ADDENDUM

ADDENDUM NO.: 02
PROJECT NAME: Kenwood Academy Link and Mechanical (Rebid)
PROJECT NO.: 05326
CONTRACT NO.: C1602R
DATE OF ISSUE: February 29, 2024

NOTICE OF CHANGES, MODIFICATIONS, OR CLARIFICATIONS TO CONTRACT DOCUMENTS

PBC Project Name: Kenwood Academy Link & Mechanical
PBC Contract No: C1802R
Project No: 05328
Title: ENLARGED PLAN - SECOND FLOOR

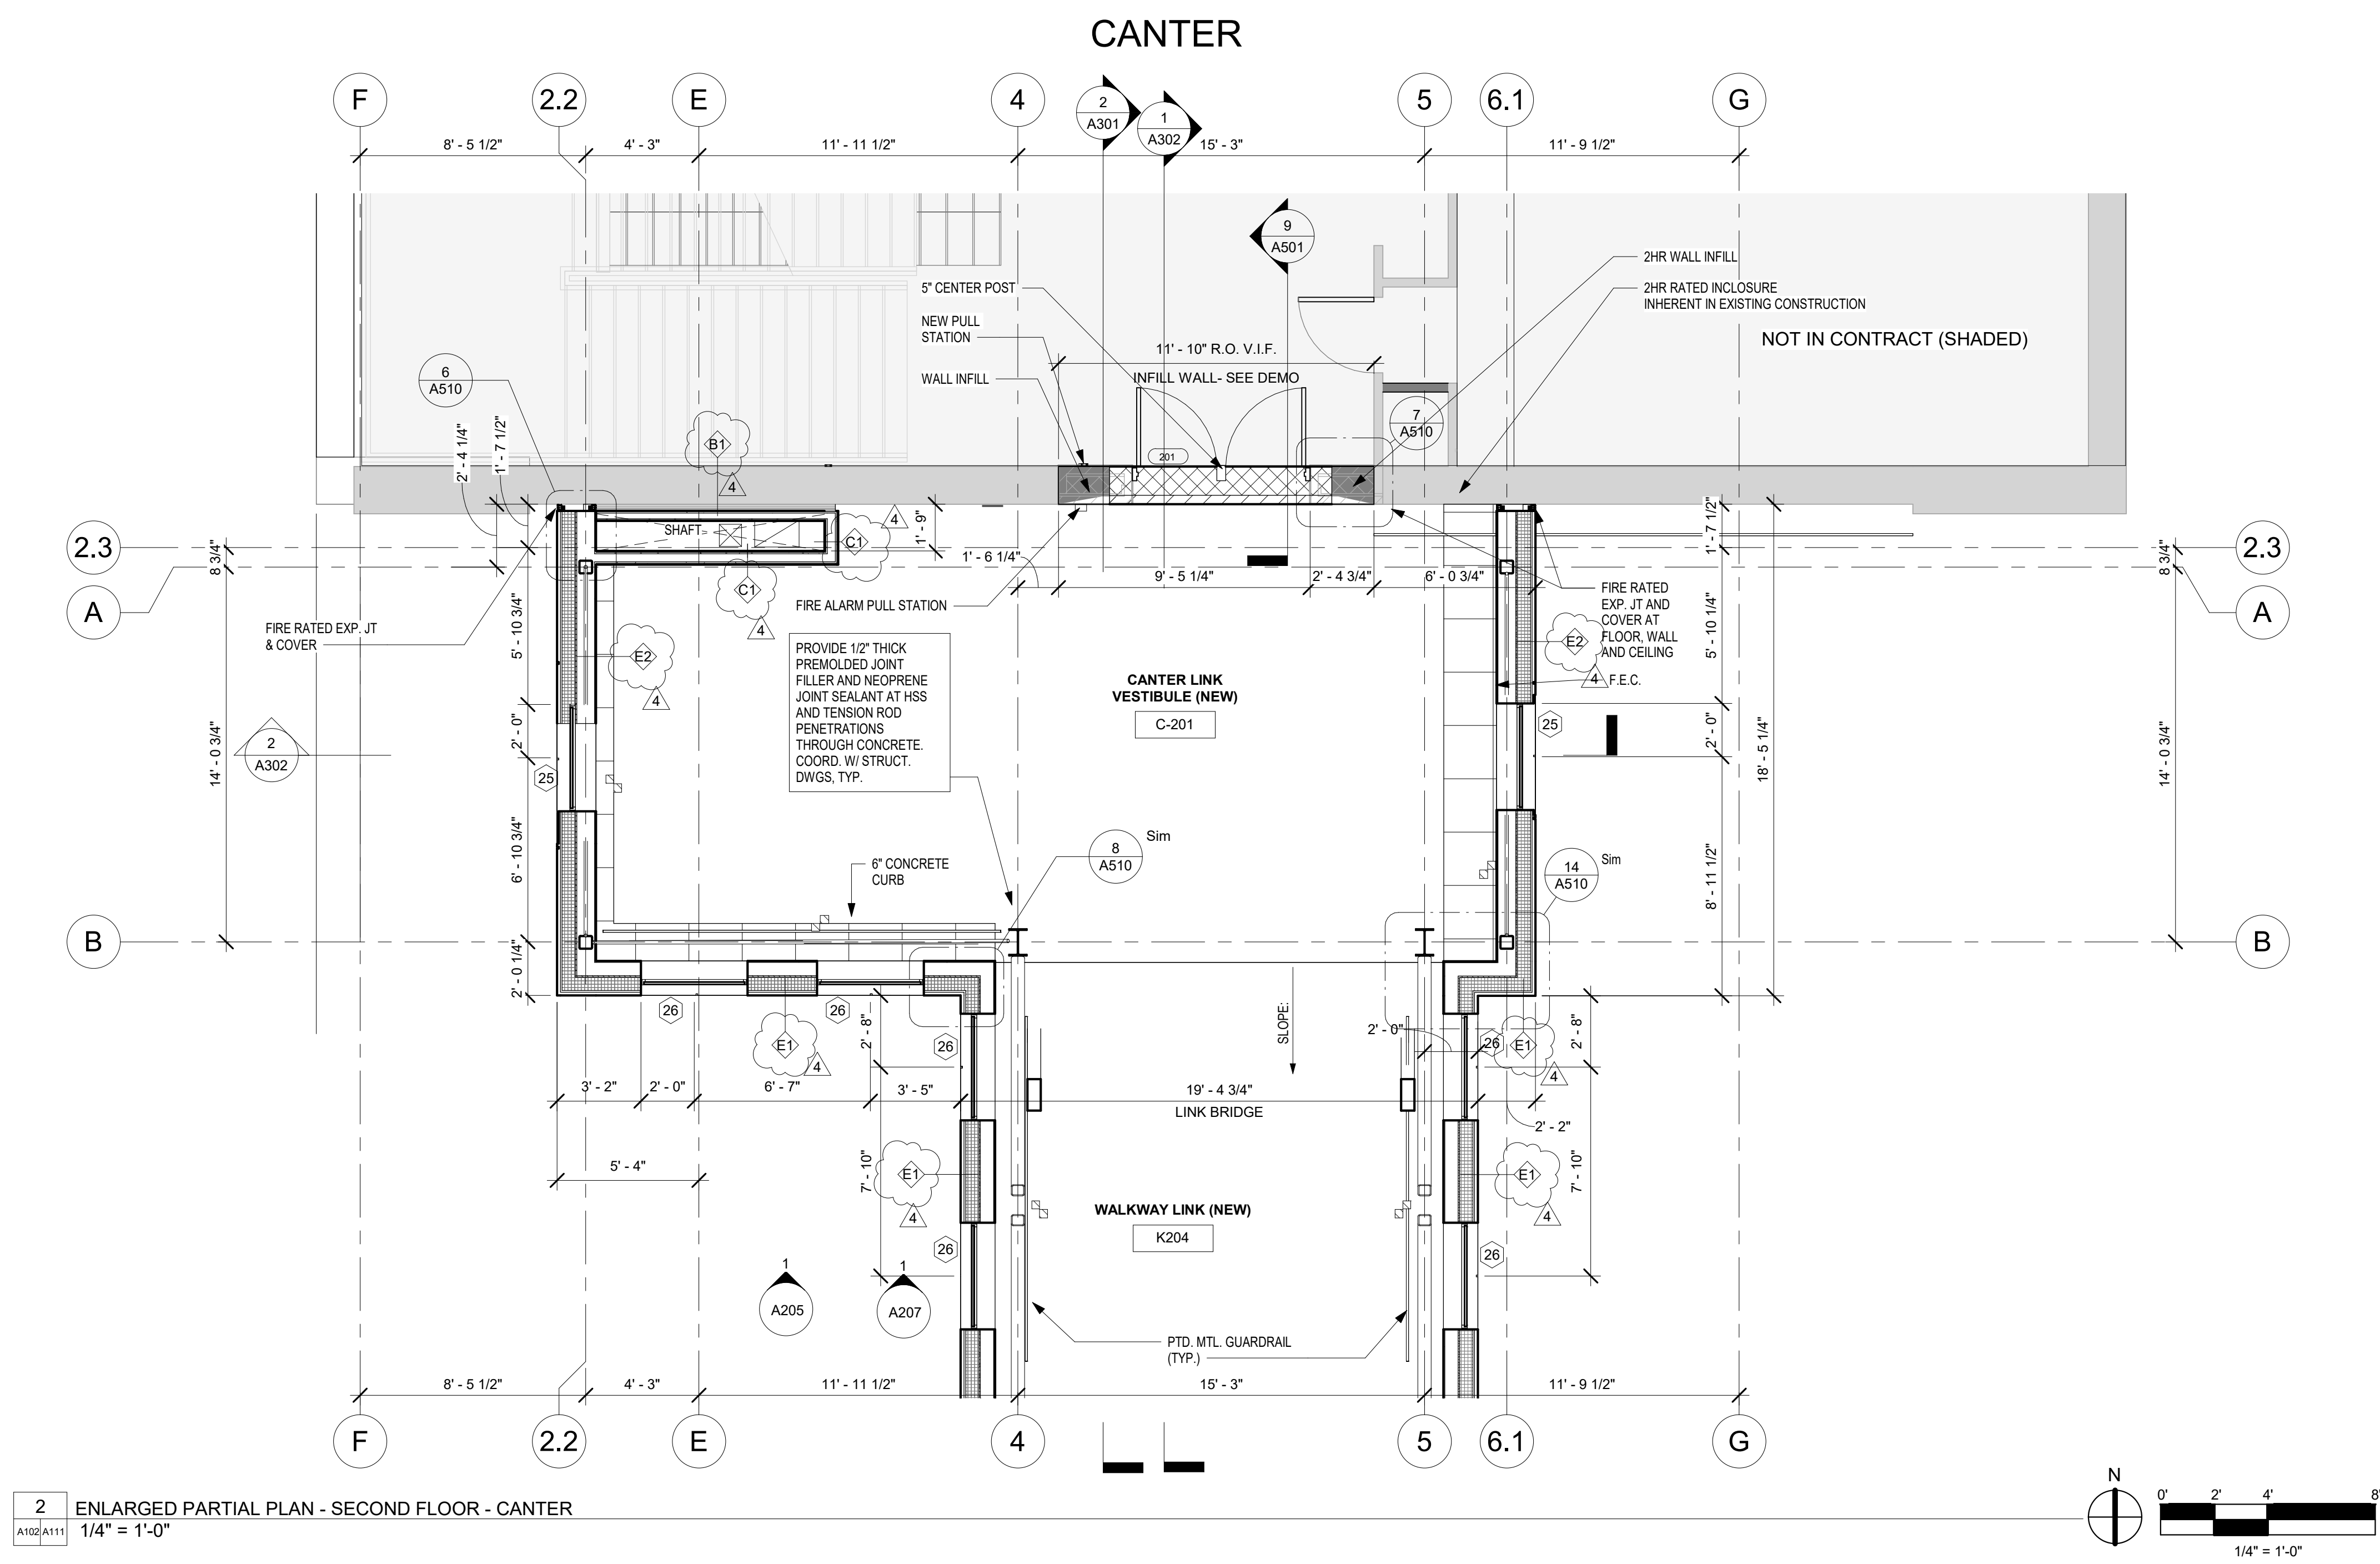
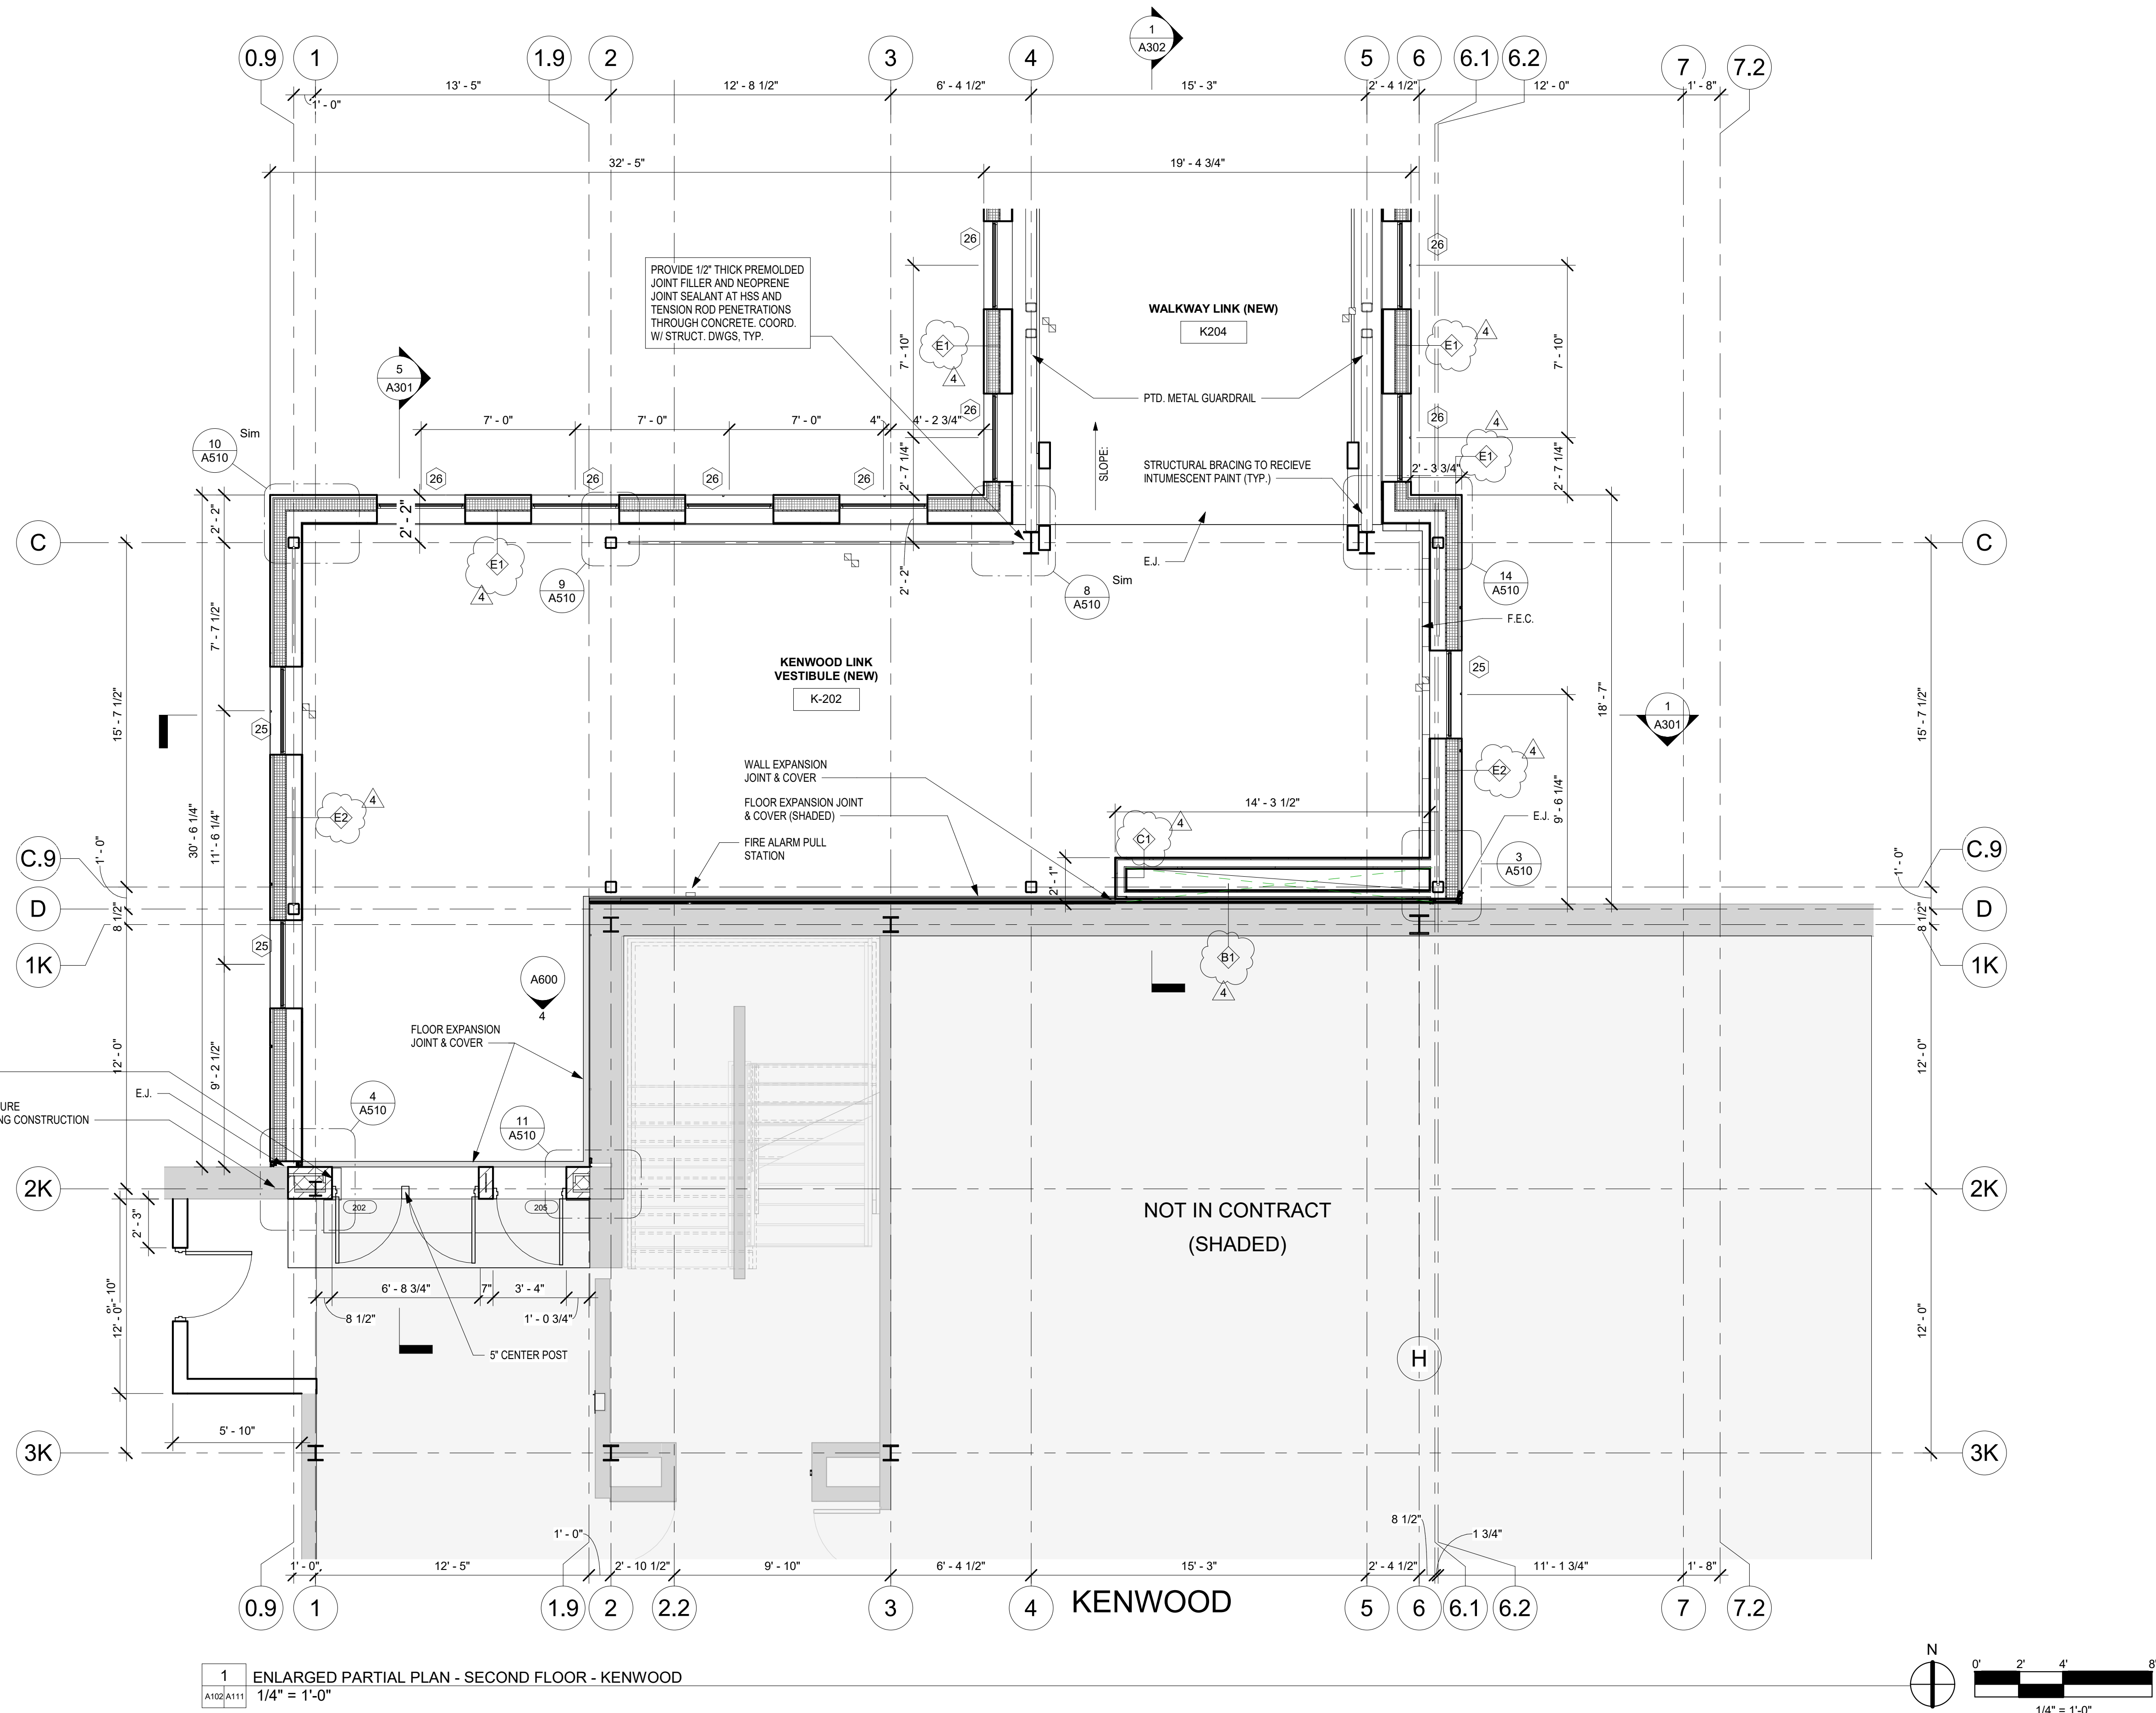
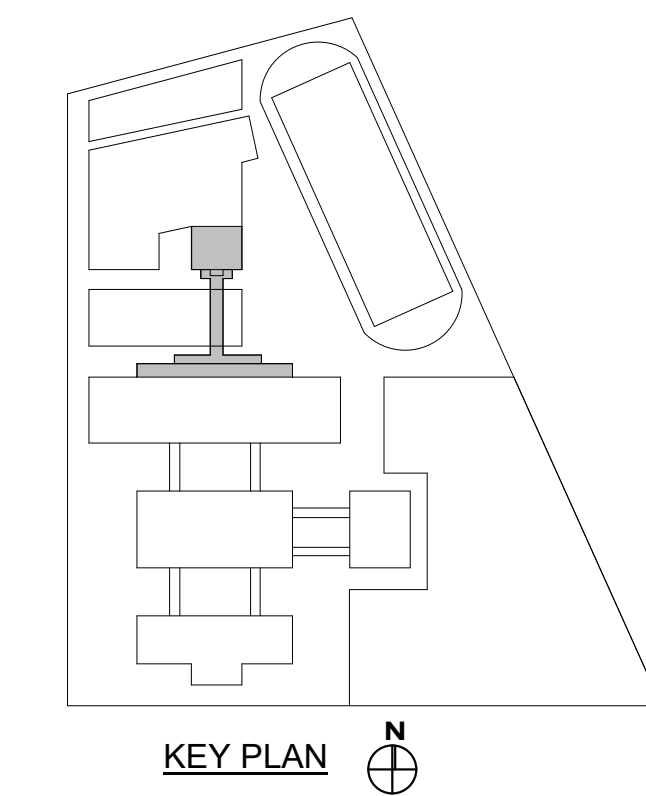
Change 9 A111 - ENLARGED PLAN 2nd floor; **REVISED** to add and revise wall tags.

Question: (Regarding Partition Types) Please note that the exterior walls/partitions in the link are not identified by partition type. Some walls are 6" CFMF and others are 8" CFMF. Can you identify which walls 6" and/or 8" by a wall type?

Question: (Regarding Partition Types) To determine the depth of the solid surface sills 5 3/4" or 7 3/4" it would be helpful to know the stud size per wall type.

Response: [All exterior Wall Types are the same construction type. 8" metal studs have a 6" HSS structural column inside the wall. 6" metal stud walls do not have a column inside. Please refer to sheets A110, A111, and A605 revised and included in this addendum.](#)

Response: [E1 partitions to have 5 3/4" sill depth and E2 partitions to have 7 3/4" sill depth. Please refer to sheets A110, A111, and A605 revised and included in this addendum.](#)
